**Seattle
Design
Commission**

MINUTES OF THE MEETING

17 January 2002

Beacon Hill Library, Corner Entry

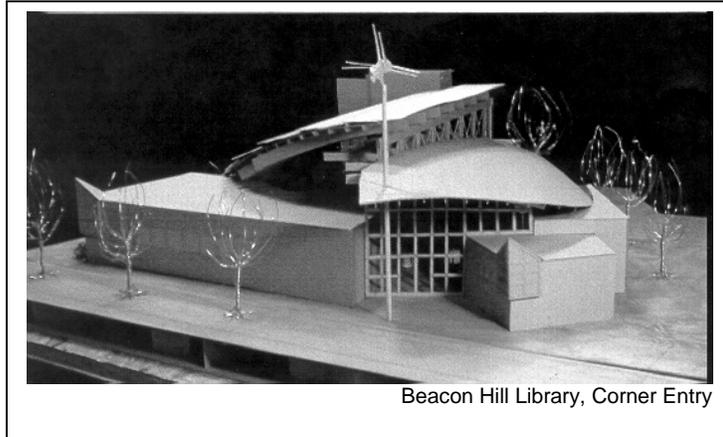
- Would like to know if the concrete of the sidewalk along Beacon Avenue South and South Forest Street would be tinted, beyond the public plaza.
 - Proponents stated that the paving elements would extend from within the entry vestibule to the public courtyard at the corner, but these paving materials and colors would not extend beyond the library's property line. Further stated that these sidewalks would be gray, and would contrast with the public plaza at the entry.

- Would like to know the nature of the column beneath the art piece at the corner. Would like to know if guywires would be used to support the piece, to further promote the boat theme. Appreciates the verticality of a single column.

- Agrees that there should be fewer "limbs" at the top of the column.
- Is concerned about the shape of the meeting room, recognizing that it extends beyond the dynamic roof.

- Feels that the public plaza is well protected from Beacon Avenue South, and the design of this corner addresses the Commission's previous concerns.
- Supports the requested vacation, based on the design development drawing that the team has presented. Feels that this design has resolved many previous concerns.

- Proponents stated that a steel tube would support the piece; at the top of the column, additional steel tubes, twisted around each other, would splay at the top to support the full weight of the art piece.

Beacon Hill Library, Floor Plan

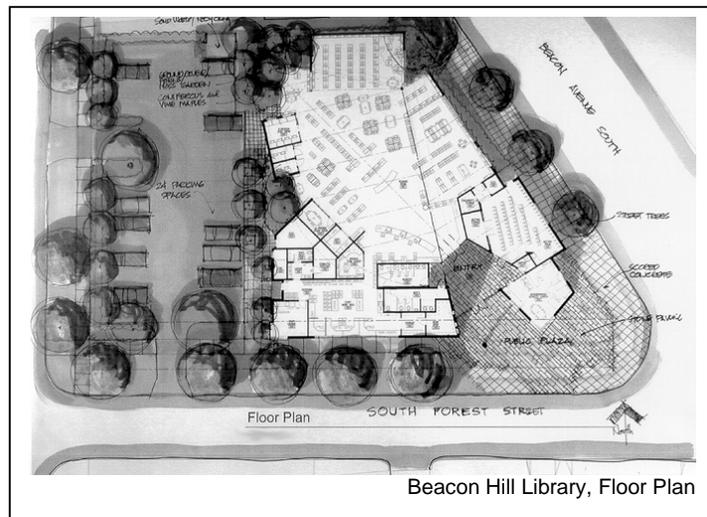
- Proponents stated that there would be a parapet along the roof of the meeting room, and the roof drainage would be controlled.
- Is concerned about the landscape design of the northeast corner of the building. Recognizing that there is a significant overhang in this area, does not believe that the plants in this area will receive sufficient sunlight.

- Recognizes that the parking lot is setback from South Forest Street, in order to maintain the setbacks of the neighborhood. Would like to know if the parking concerns have been resolved.

- Would like to know if the water, collected from these roof drains, could be collected or directed to a recycling, re-use system.
 - Proponents stated that this concept has been discussed. Further stated that these drains may be directed to the main landscaped areas.

- Is concerned about the roof and the structural elements required for these forms. Hopes that the clerestory windows and other views will not be affected by this structure.

- Proponents recognized this valid concern and stated that there is a palette of plants to consider for this area. Further stated that this planted area is meant to keep people away from the building. Further stated that the curved roof would pull back from this edge to a greater extent than that which is portrayed in the model.

- Proponents stated that the west building façade, facing the parking area, has been refined, and there will be a landscape buffer between the parking area and the building. The existing vegetation on the west edge of the site will remain. Further stated that this design portrays only twenty-four parking spaces, which does not meet code requirements and requires a variance.
